## Addendum #3

**Project:** Hamilton-Wentworth District School Board  
REFERENCE NO. 2025-137-P02085  
Franklin Road Music Corridors and Washroom Renovation

## **Addendum No. 2**

**Project:** HWDSB-P02085 – Franklin Road ES Renovation

drawn: MD  
 scale: NTS  
 date: project number: 24-21  
 checked: MD  
 DRAWING NO: E3-00  
 date: 08/2024  
 0  
 Revision

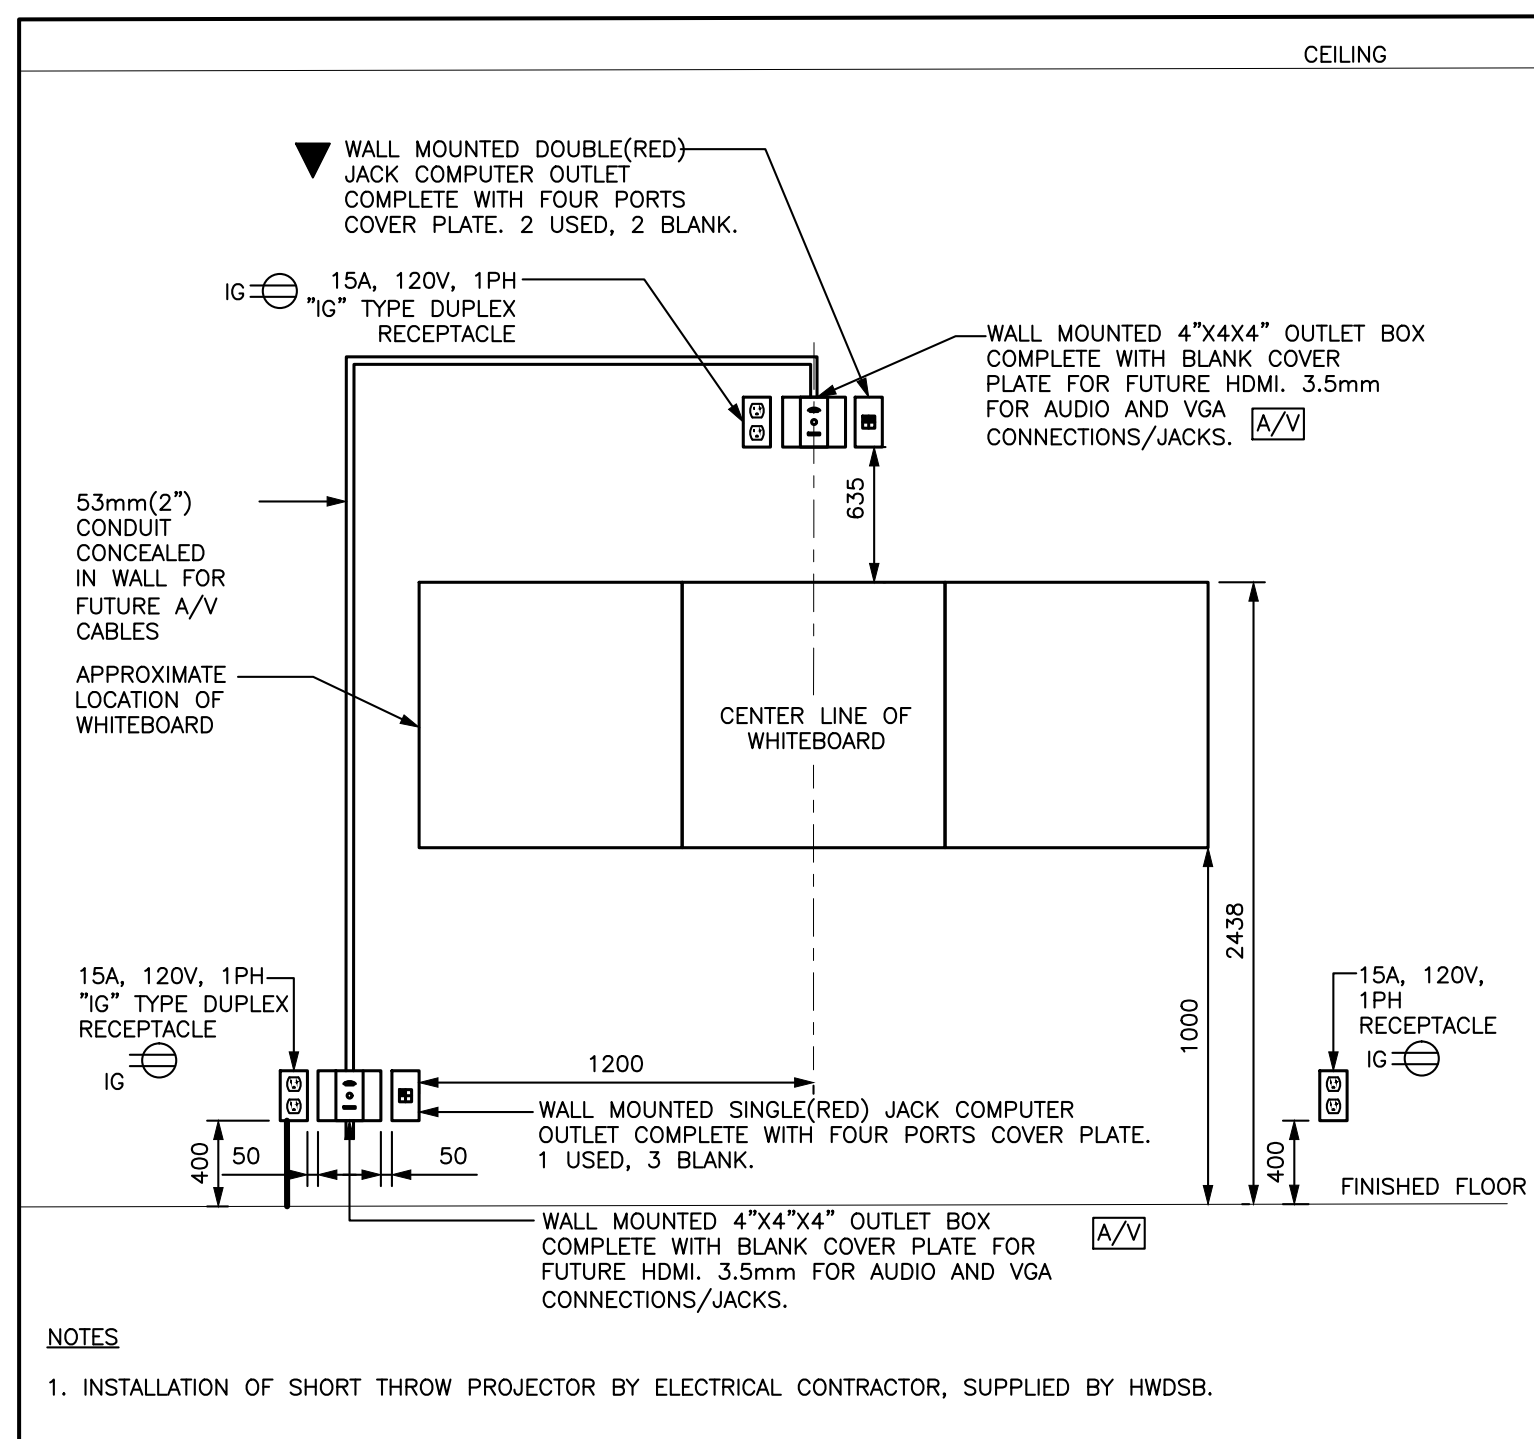
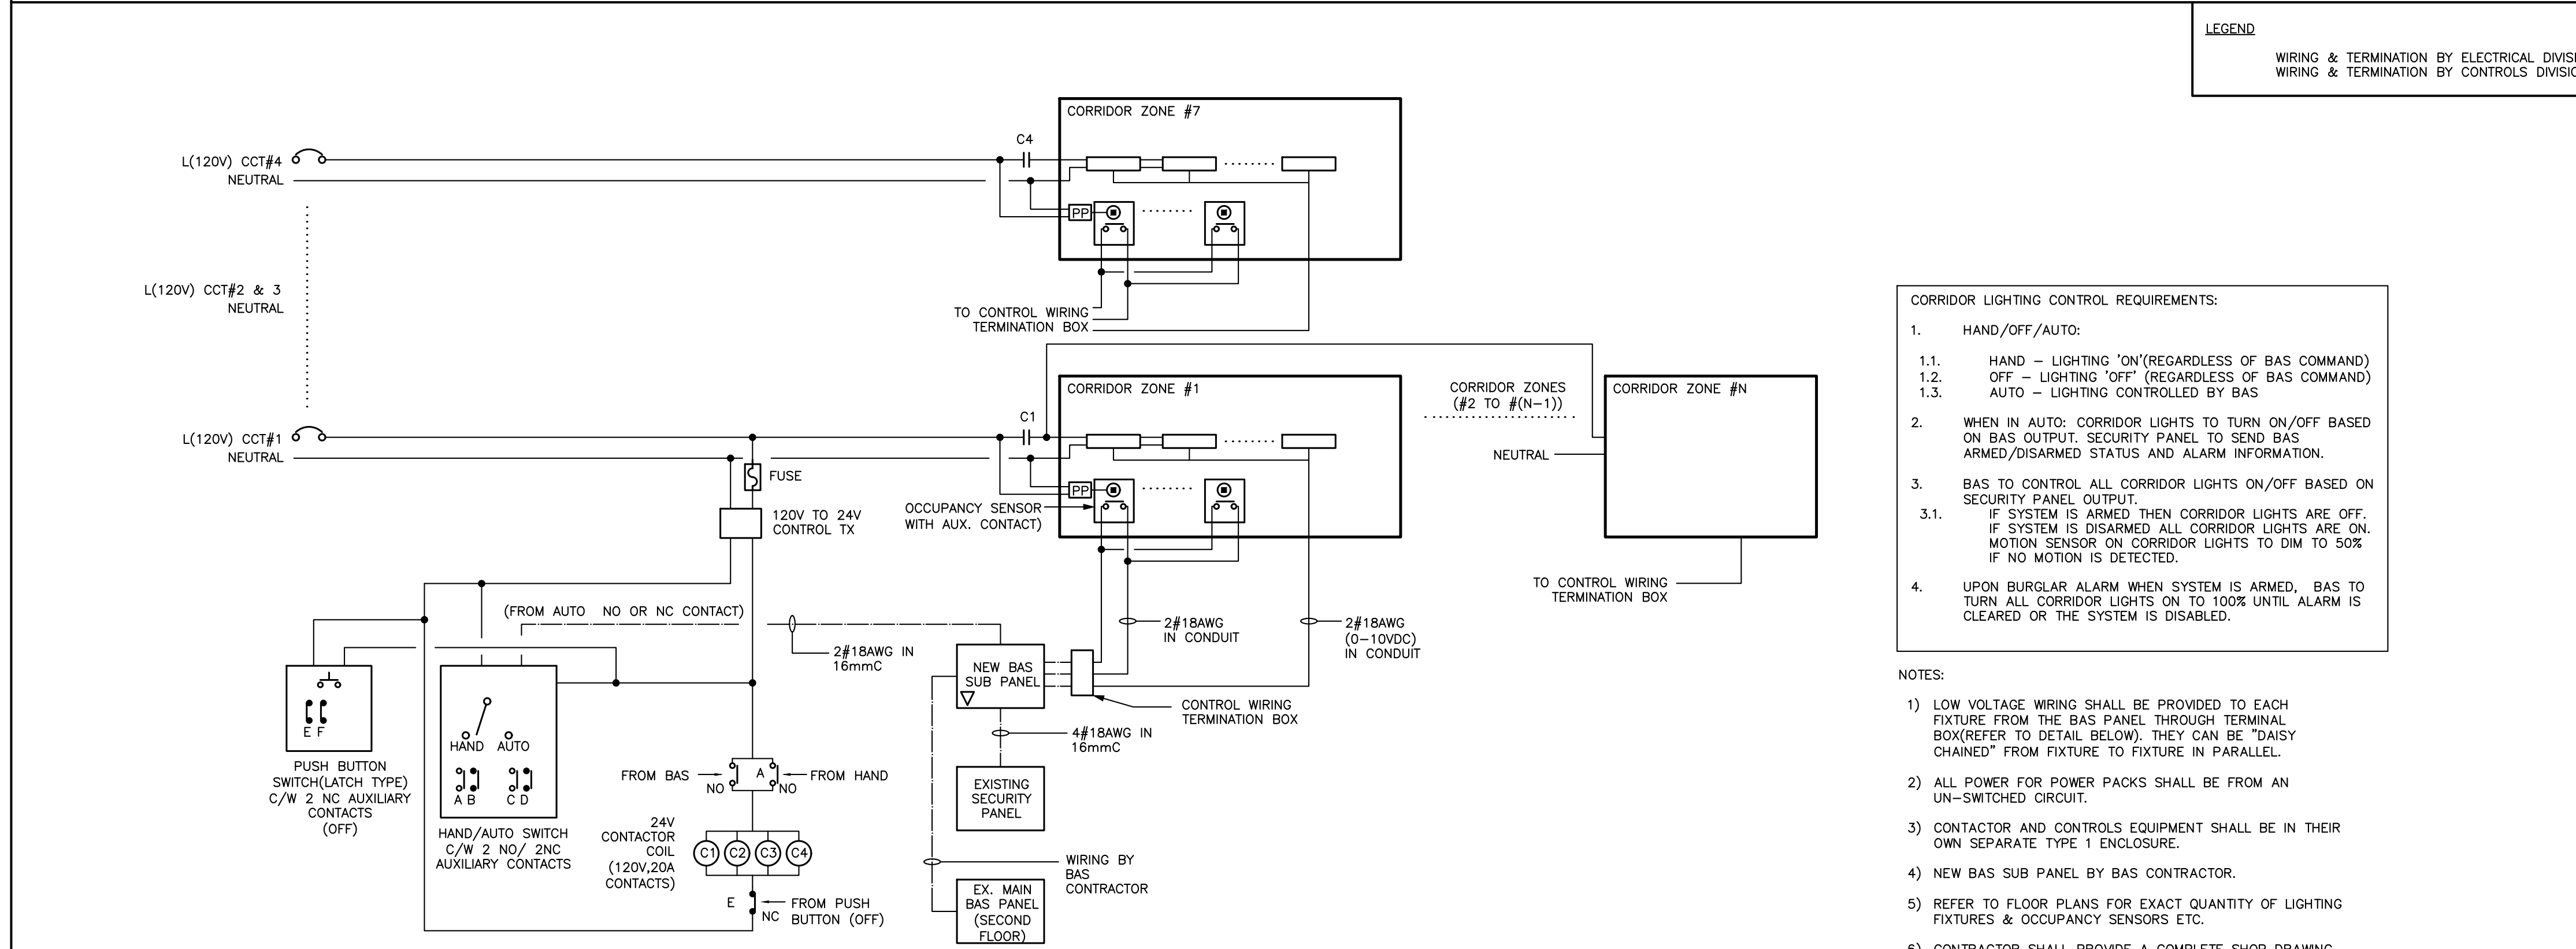
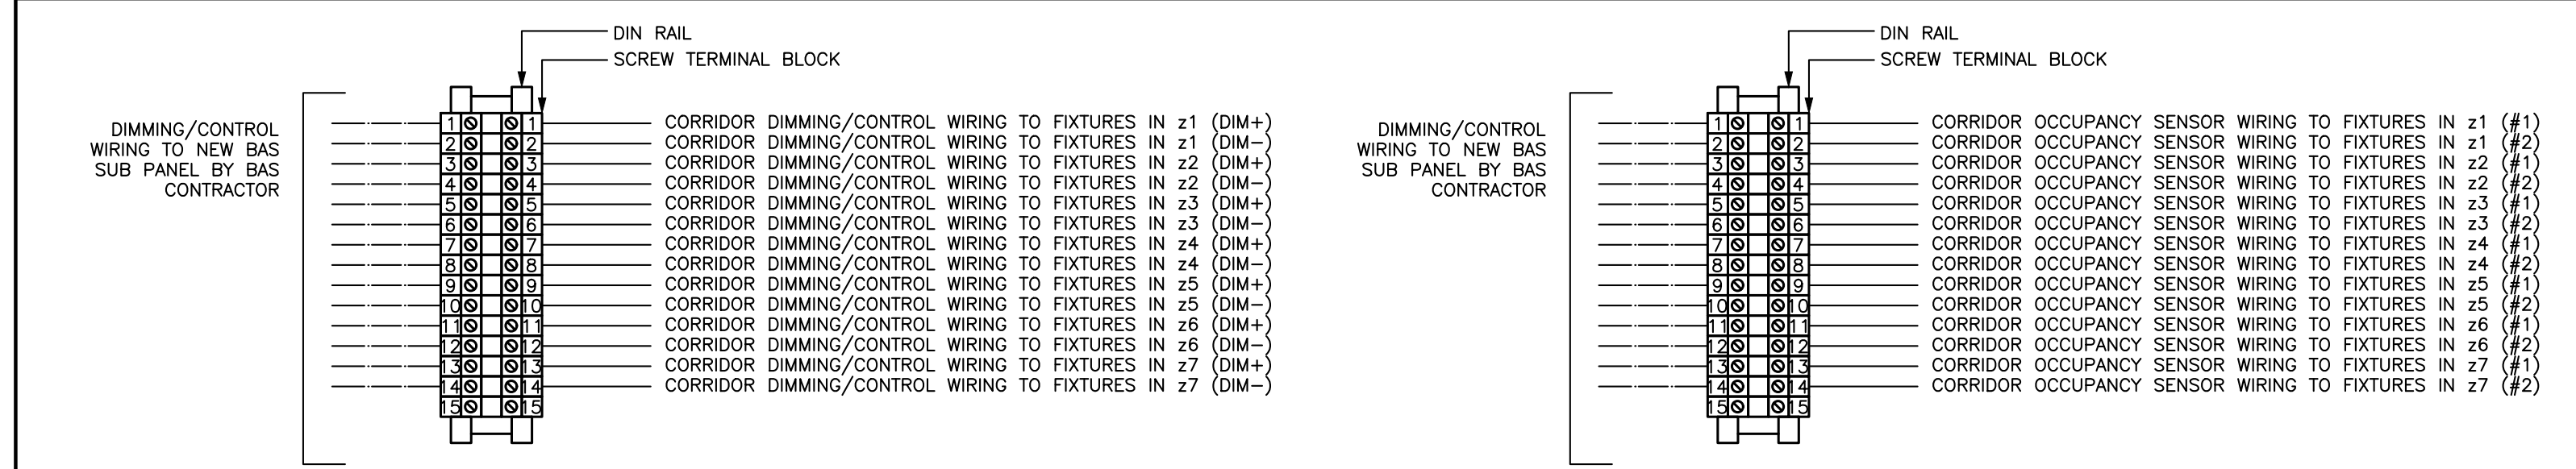
### **5).Drawing E3-00**

- .1 **ADD** corridor lighting control detail as shown.
- .2 **REVISE** occupancy and lighting fixture schedule as shown.
- .3 **REVISE** breakers in panel schedule LP-W & LP-X as shown.

### CORRIDOR/LOBBY LIGHTING

- CORRIDOR LIGHTING CONTROL REQUIREMENTS:
- HAND/OFF/AUTO:
    - HAND - LIGHTING 'ON' (REGARDLESS OF BAS COMMAND)
    - OFF - LIGHTING 'OFF' (REGARDLESS OF BAS COMMAND)
    - AUTO - LIGHTING CONTROLLED BY BAS
  - WHEN IN AUTO: CORRIDOR LIGHTS TO TURN ON/OFF BASED ON BAS OUTPUT. SECURITY PANEL TO SEND BAS ARMED/DISARMED STATUS AND ALARM INFORMATION.
  - BAS TO CONTROL ALL CORRIDOR LIGHTS ON/OFF BASED ON SECURITY PANEL OUTPUT.
    - IF SYSTEM IS ARMED THEN CORRIDOR LIGHTS ARE OFF. IF SYSTEM IS DISARMED ALL CORRIDOR LIGHTS ARE ON. MOTION SENSOR ON CORRIDOR LIGHTS TO DIM TO 50% IF NO MOTION IS DETECTED.
  - UPON BURGLAR ALARM WHEN SYSTEM IS ARMED, BAS TO TURN ALL CORRIDOR LIGHTS ON TO 100% UNTIL ALARM IS CLEARED OR THE SYSTEM IS DISABLED.

- NOTES:
- LOW VOLTAGE WIRING SHALL BE PROVIDED TO EACH FIXTURE FROM THE BAS PANEL THROUGH TERMINAL BOX (REFER TO DETAIL BELOW). THEY CAN BE "DAISY CHAINED" FROM FIXTURE TO FIXTURE IN PARALLEL.
  - ALL POWER FOR POWER PACKS SHALL BE FROM AN UN-SWITCHED CIRCUIT.
  - CONTACTOR AND CONTROLS EQUIPMENT SHALL BE IN THEIR OWN SEPARATE TYPE 1 ENCLOSURE.
  - NEW BAS SUB PANEL BY BAS CONTRACTOR.
  - REFER TO FLOOR PLANS FOR EXACT QUANTITY OF LIGHTING FIXTURES & OCCUPANCY SENSORS ETC.
  - CONTRACTOR SHALL PROVIDE A COMPLETE SHOP DRAWING FOR CORRIDOR LIGHTING CONTROLS INCLUDING ALL PARTS, WIRING ETC.
